UNITED STATES PATENT AND TRADEMARK OFFICE

Office Action Summary

10/695,178

DETAILED ACTION

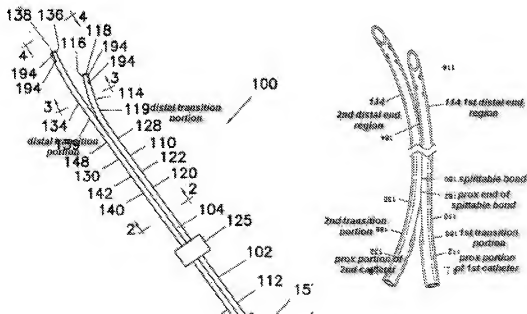
The drawings are objected to under 37 CFR 1.83(a). The drawings must show every feature of the invention specified in the claims. Therefore, the limitation "the first and second catheters have transition sections between the first and second proximal end regions and the first and second intermediate sections" of claim 36 must be shown or the feature(s) canceled from the claim(s). No new matter should be entered.

Claim 36 is rejected under 35 U.S.C. 112, first paragraph, as failing to comply with the written description requirement. The claim(s) contains subject matter which was not described in the specification in such a way as to reasonably convey to one skilled in the relevant art that the inventor(s), at the time the application was filed, had possession of the claimed invention. Nowhere in the specification discloses that the limitation "the first and second catheters have transition sections between the first and second proximal end regions and the first and second intermediate sections." According to Figs 1 and 7 below, a first and second catheters have transition sections 119/139 (Fig. 1) or 186/188 (Fig. 7) between the first and second distal end regions and the first and second proximal portion.

According to para [0042] of Specification, the first transition portion 186 and second transition portion 188 are located in the very near proximity of the proximal end 182 of the splittable bond 180.

Corrected drawing sheets in compliance with 37 CFR 1.121(d) are required in reply to the Office action to avoid abandonment of the application. Any amended replacement drawing sheet should include all of the figures appearing on the immediate prior version of the sheet, even if only one figure is being amended. The figure or figure number of an amended drawing should not be labeled as "amended." If a drawing figure is to be canceled, the appropriate figure must be removed from the replacement sheet, and where necessary, the remaining figures must be renumbered and appropriate changes made to the brief description of the several views of the drawings for consistency. Additional replacement sheets may be necessary to show the renumbering of the remaining figures. Each drawing sheet submitted after the filing date of an application must be labeled in the top margin as either "Replacement Sheet" or "New Sheet" pursuant to 37 CFR 1.121(d). If the changes are not accepted by the examiner, the applicant will be notified and informed of any required corrective action in the next Office action. The objection to the drawings will not be held in abeyance.
